# **Origination Form**

# Proposed Revisions to a Standard Plans Index

Originator:	Saha, Dibakar	Index Number:	654-001
Date:	7/7/2025	Sheet Number(s):	1
E-mail:	dibakar.saha@dot.state.fl.us	Index Title:	Rectangular Rapid Flashing Beacon Assembly

RECTANGULAR RAPID FLASHING BEACON ASSEMBLY

654-001 1 of 2

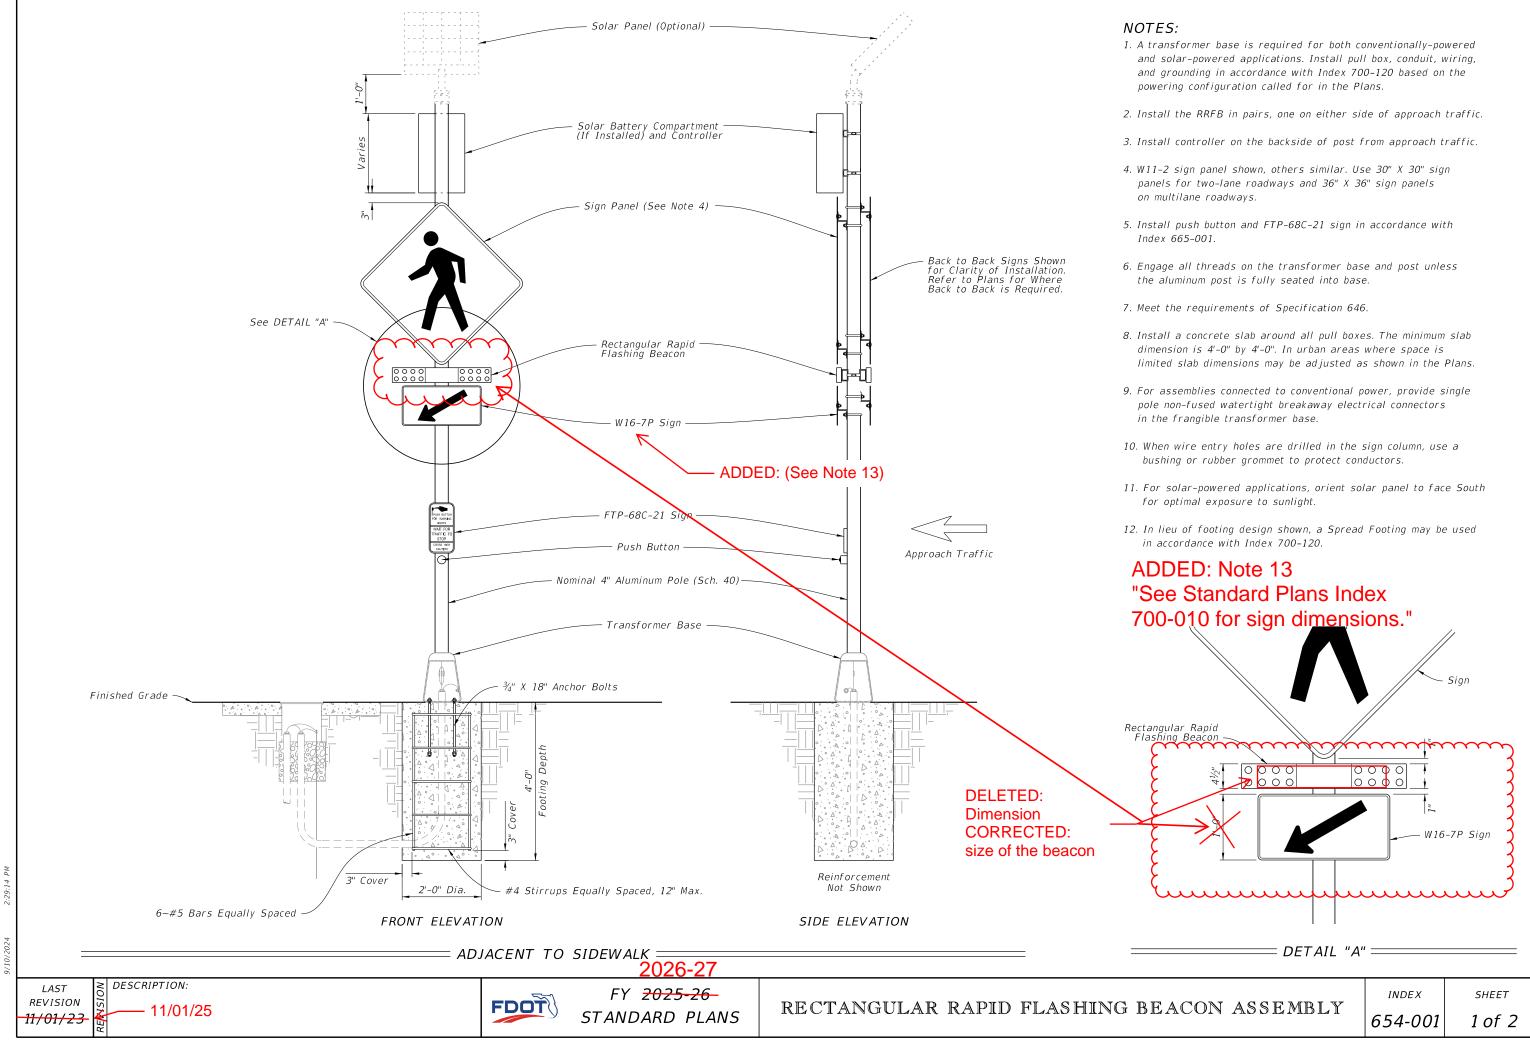
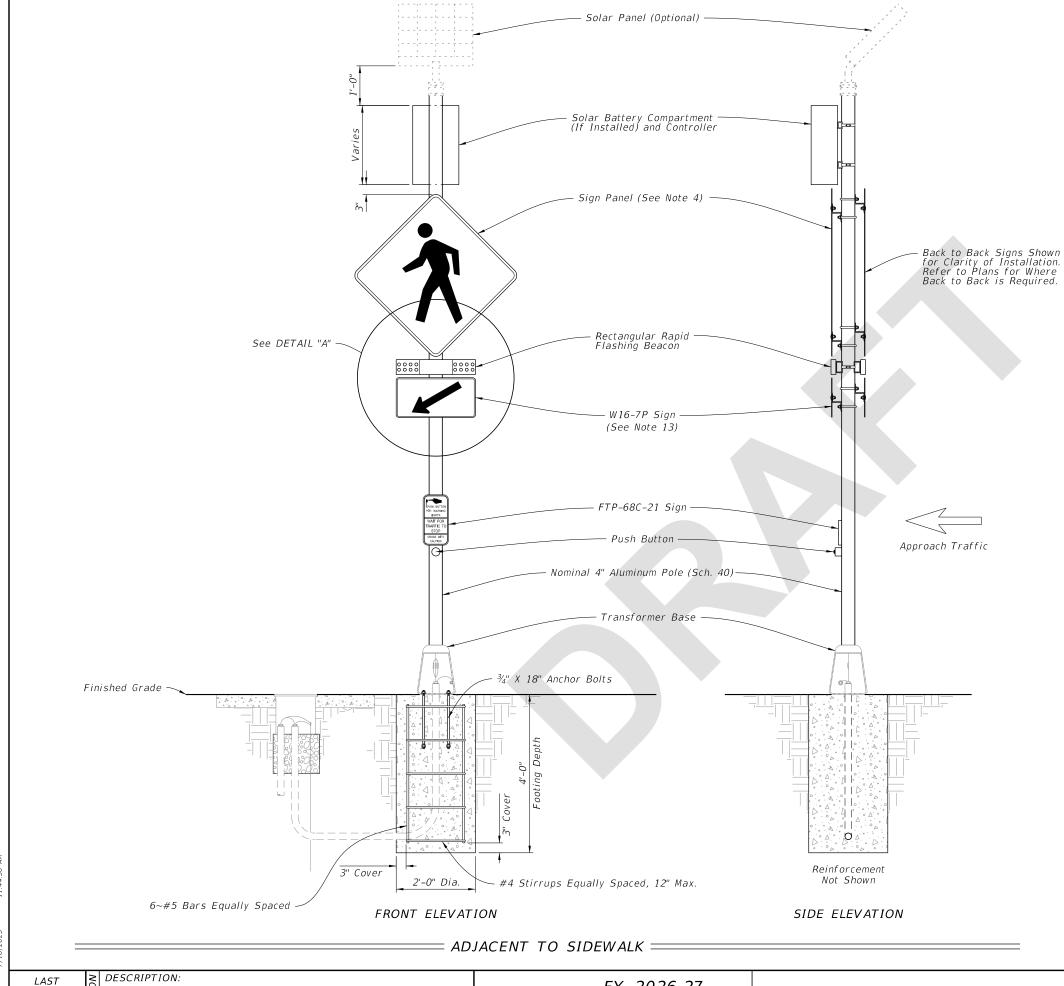
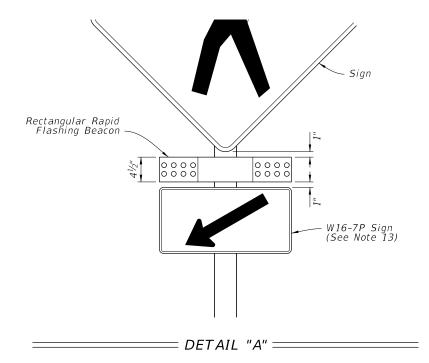
Sheet 1: Deleted the 1'-0" dimension and corrected the size of the beacon in FRONT ELEVATION and DETAIL "A"; Added Note 13 "See Standard Plans Index 700-010 for sign dimensions."; Added "(See Note 13)" to the W16-7P Sign in the ADJACENT TO SIDEWALK Detail.

Updated W16-7P and Rectangular Rapid Flashing Beacon (RRFB) depiction to more accurately represent dimensions. As W16-7P dimensions depend on the size of W11-2 sign panel, a note 13 was added to send the user to Standard Plans Index 700-010 for the appropriate dimensions.

- 12. In lieu of footing design shown, a Spread Footing may be used in accordance with Index 700-120.
- 13. See Standard Plans Index 700-010 for sign dimensions.
